**Flood Control Project Maintenance
Levee Inspections**

Fall 2016 Levee Maintenance Deficiency Summary Report

Reclamation District No. 0501 Ryer Island

Fall 2016 Levee Inspection Results

Photo 1 of 1 : FA_2016_RD0501_169_1_20161018_00001.jpg

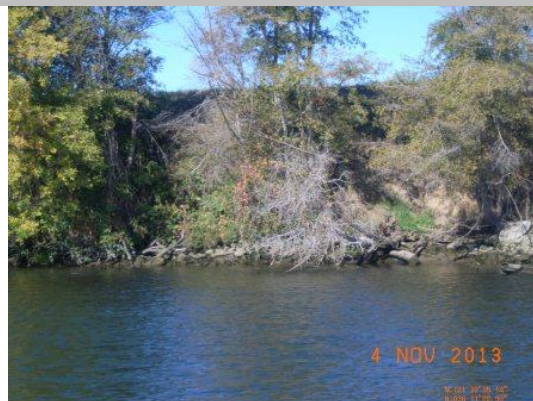
LM Start	5.77	Rating **	M	Issue No.	1
LM End	5.84	Issue Type +	Ma	Location *	WS
Category	Supplemental			GPS Latitude/Longitude	
				Start	End
Item	2015 USACE Erosion Survey, DRAFT			38.190001 °	38.189311 °
				-121.643160 °	-121.643917 °
DWR ID	DWR_RD0501_01_f_2016_1				
Comment Code					
Inspector Comment					
2008 - Overstepped levee section with multiple small pockets of erosion 10 - 20 ft wide. 2013 - Site has fresh erosion and taller vertical sections. 2015: No observed changes. [2015 Site ID: STM_15-7_R]

Photo 2 of 2 : UCIP_FA_2016_44865_58972.jpg

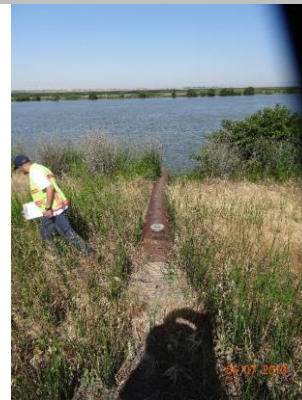
Comment Code					
Inspector Comment					
FS_ID:44865 DS_ID:21038 EP_NO: 2817 Repair Type: Non-Urgent Crossing Status: Found UCIP Comments: Dense vegetation limits the inspector's visibility to identify signs of pipe failure (leaks) through the slope. Recommend removing vegetation along pipe alignment to conduct proper inspection of structure and appurtenances. Scour hole located on waterward side. FIELD_STRUCT_DESC: 20-inch steel drainpipe sleeved through a 24-inch steel pipe through the levee, 9.0 feet below the crown. Flap gate on waterward end. Two cutoff collars around the pipe at both shoulders. Pipe exposed along both slopes. Rock revetment on waterward slope. Berm on waterward side is over 20 feet. (Permit No. 2817-1959) FS Date: 6/7/2013

View of waterward side--pipe section exposed and siphon breaker. Over 20 feet berm on waterward side.

Photo 1 of 2 : UCIP_FA_2016_32541_59008.jpg

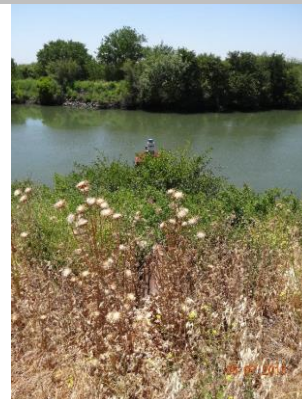
FS_ID:32541
DS_ID:21071
EP_NO: N/A
Repair Type: Non-Urgent
Crossing Status: Found
UCIP Comments: --Contact owner--Dense vegetation limits the inspector's visibility to identify signs of pipe failure (leaks) along the waterward and landward slopes. Recommend removing vegetation along pipe alignment to conduct proper inspection of structure and appurtenances. Walkway and siphon breaker not found.
FIELD_STRUCT_DESC: 12-inch concrete pipe through the levee, 2.5 feet below the crown. Cutoff wall around pipe at center of levee. Siphon breaker on apex of pipe at shoulder. Pump on pile structure in stream. Walkway access to pump. (USACE-1959). This entry matches the Drainage or Irrigation Structure referenced in O&M manual (HLM 5.10).
FS Date: 6/7/2013

View of waterward side. Pump located on pile structure in stream.

Photo 1 of 2 : UCIP_FA_2016_50025_59039.jpg

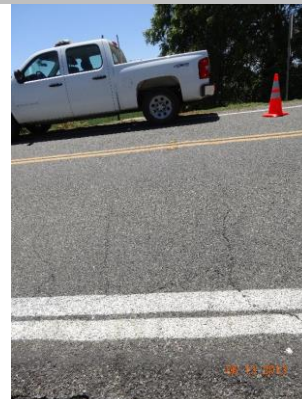
Comment Code					
Inspector Comment					
FS_ID:50025 DS_ID:21063 EP_NO: 11812 Repair Type: Non-Urgent Crossing Status: Found UCIP Comments: 8/22/2016 Crossing has been downgraded from Urgent to Non-Urgent no levee damage appears to be present along pipe alignment. There appears to be an erosion site adjacent to this crossing. Need to coordinate with DWR Inspectors. (DWR UCIP - omagana)6/07/2013 Open cut section of levee on LS slope 8 foot wide--repair work needed. Abandoned pump on waterward berm. Dense vegetation--Recommend removing vegetation along pipe alignment to conduct proper inspection of structure and appurtenances on waterward side. (DWR UCIP - omagana) FIELD_STRUCT_DESC: 14-inch steel pipe and 1.25-inch electrical conduit through the levee, both 3.0 feet below the crown. Cutoff wall around pipe and conduit at center of levee. Siphon breaker on apex of pipe at landward shoulder. Slant pump on waterward slope. Discharge structure at landward toe. Rock revetment on waterward slope. (Permit No. 11812-1976) FS Date: 8/22/2016

Photo 1 of 2 : UCIP_FA_2016_32546_59047.jpg

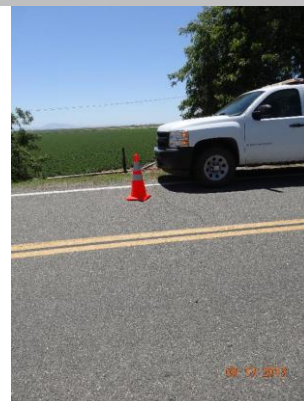
Comment Code					
Inspector Comment					
FS_ID:32546 DS_ID:21064 EP_NO: N/A Repair Type: Non-Urgent Crossing Status: Found UCIP Comments: Debris (pipe section) located on waterward berm. Dense vegetation limits the inspector's visibility to identify signs of pipe failure (leaks) along the waterward slope. Recommend removing vegetation along pipe alignment to conduct proper inspection of structure and appurtenances. FIELD_STRUCT_DESC: 8-inch steel pipe through the levee, 2.7 feet below the crown. Pump in pump house at landward toe. (USACE-1959). This entry matches the Drainage or Irrigation Structure referenced in O&M manual (HLM 8.20). FS Date: 6/13/2013

Photo 2 of 2 : UCIP_FA_2016_32550_59067.jpg

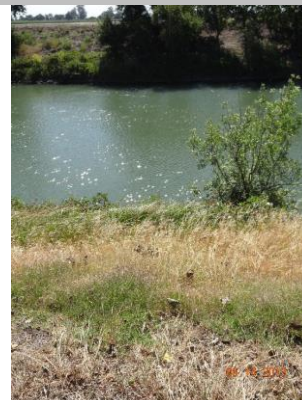
View of waterward side.

Photo 2 of 2 : UCIP_FA_2016_32551_59072.jpg

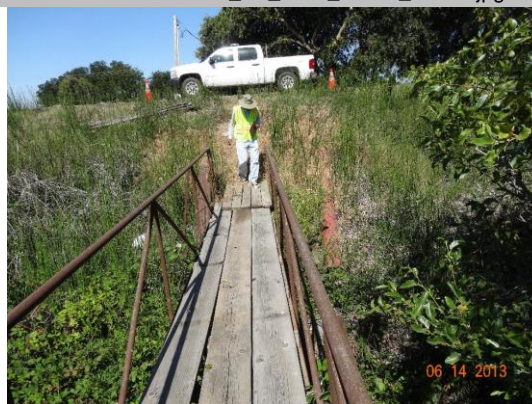
Abandoned pipe to the right of walkway.
